IN THE DRAWINGS:

REMARKS

This Amendment is submitted in response to the Office Action dated June 22, 2005. In the Office Action, the Patent Office objected to the drawings under 37 CFR §1.83(a) and to Claim 6 under 35 U.S.C. §112, first paragraph, for failing to comply with the written description requirement. Additionally, the Patent Office rejected Claims 1-3, 7, 9, 10, 14 and 18 under 35 U.S.C. §102(b) as being anticipated by *Miller* (U.S. Patent No. 1,780,269); Claims 8, 12 and 13 under 35 U.S.C. §103(a) as being unpatentable over *Miller*; Claims 4, 11 and 19 under 35 U.S.C. §103(a) as being unpatentable over *Miller* in view of *Marovich* (U.S. Patent No. 4,068,421); Claims 5 and 17 under 35 U.S.C. §103(a) as being unpatentable over *Miller* in view of Japanese Patent No. 2002-146913 to *Kawarazaki*; and Claims 15, 16 and 20 under 35 U.S.C. §103(a) as being unpatentable over *Miller* in view of *Lynch* (U.S. Patent No. 3,670,466).

FIG.3A

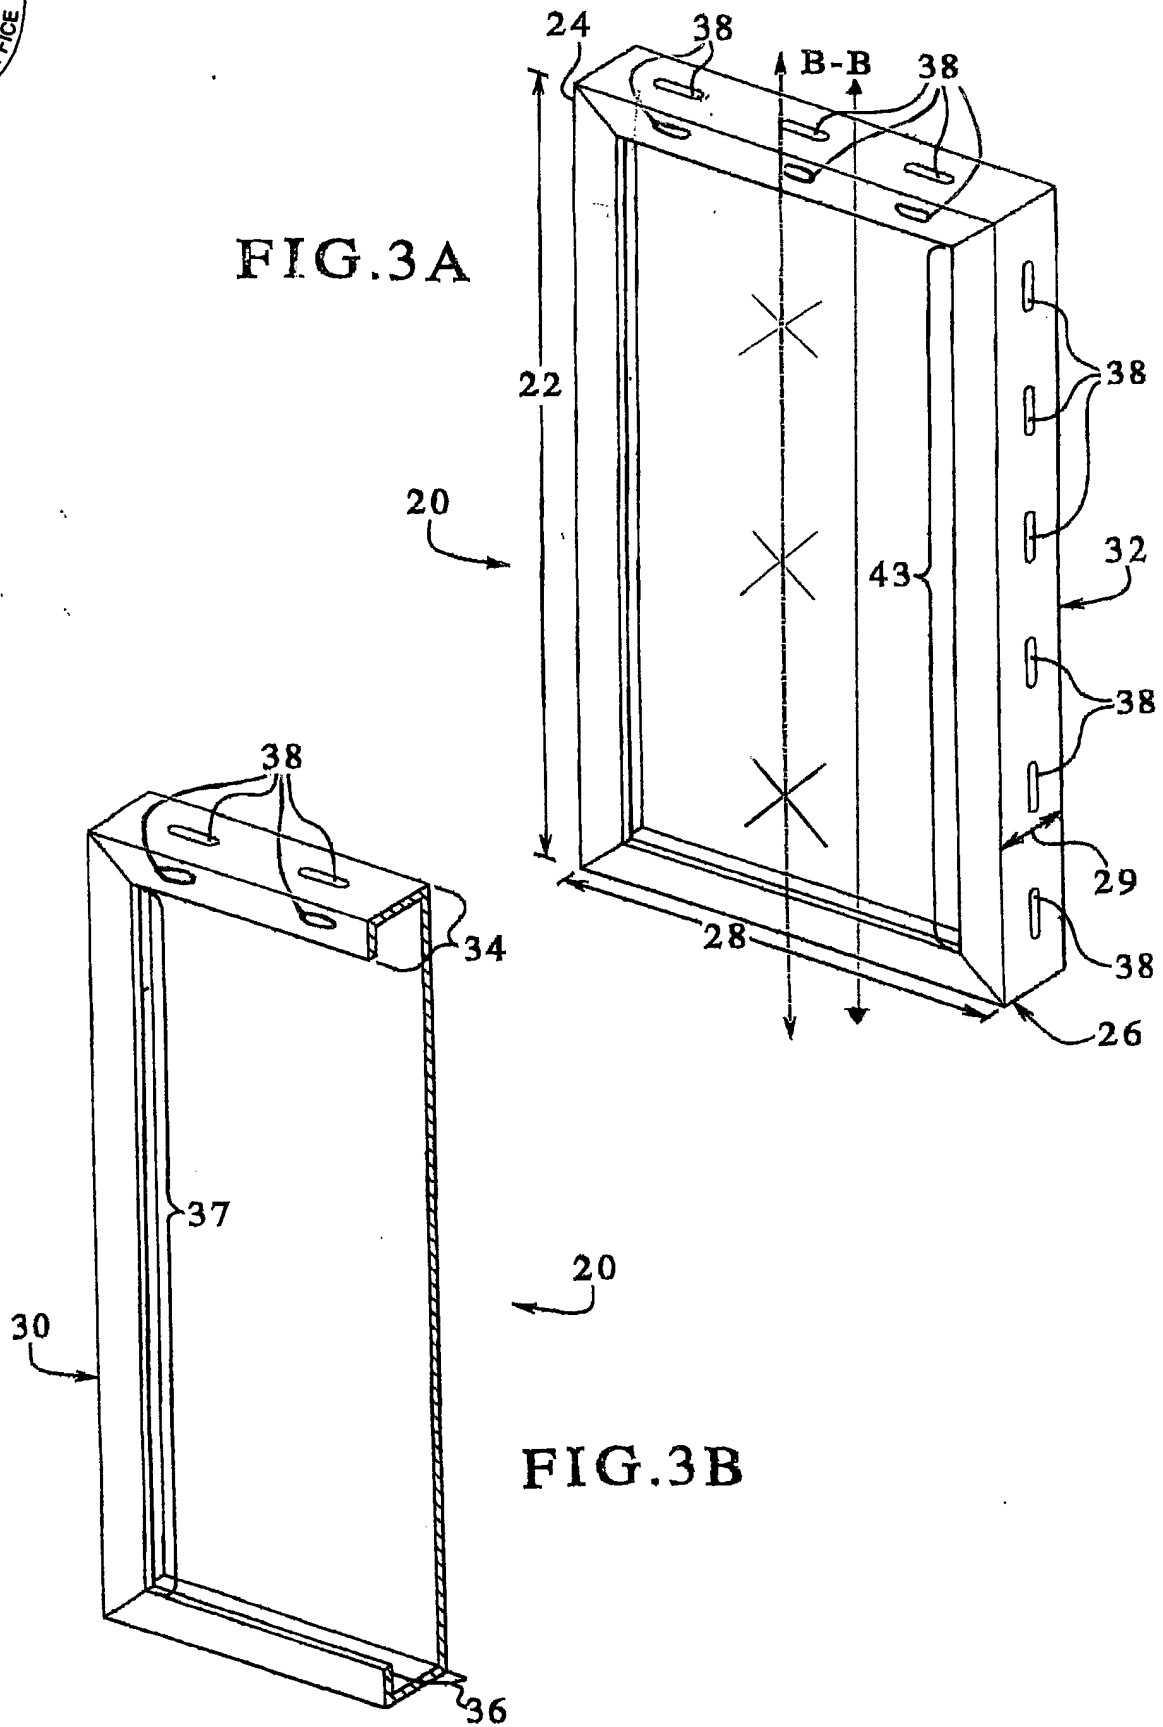
FIG. 3A has been corrected as shown in the Replacement Drawing Sheet and as shown in red in the Annotated Sheet Showing Changes in the attached Appendix.

In the Office Action, the Patent Office objected to the drawings as failing to show every feature of the invention specified in the claims. Namely, the Patent Office asserts that Fig. 6 shows an element labeled "46" which should be labeled "4b". In response to the objection, Applicant amended Fig. 6 by labeling the element "4b". Further, the Patent Office asserts that Fig. 3A and Fig. 3B fail to show the slots on the roof panels extending parallel to the body as illustrated in Fig. 5. Accordingly, Applicant amended Fig. 3A and Fig. 3B to show the slots illustrated by Fig. 5. The slots on the roof panels extending parallel to the body as illustrated by Fig. 5 are disclosed in the specification as filed. Specifically, page 9, lines 19 and 20 state: "Slots 38 may be provided within the section 34 and/or the section 36." Applicant submits that the amendments to Fig. 3A, Fig. 3B and Fig. 6 overcome the objections by the Patent Office. Notice to that effect is requested.

FIG. 6

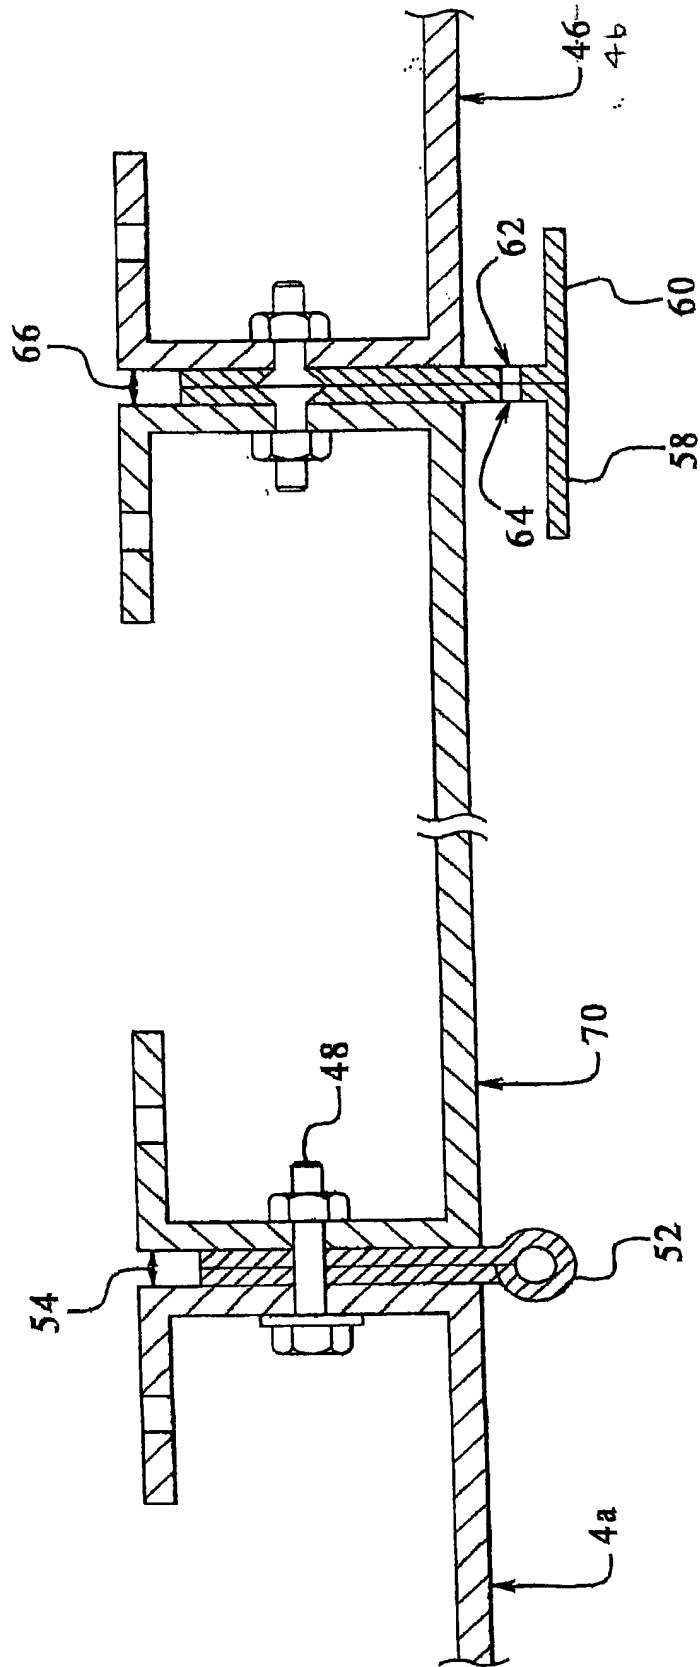
FIG. 6 has been corrected as shown in the Replacement Drawing Sheet and as shown in red in the Annotated Sheet Showing Changes in the attached Appendix.
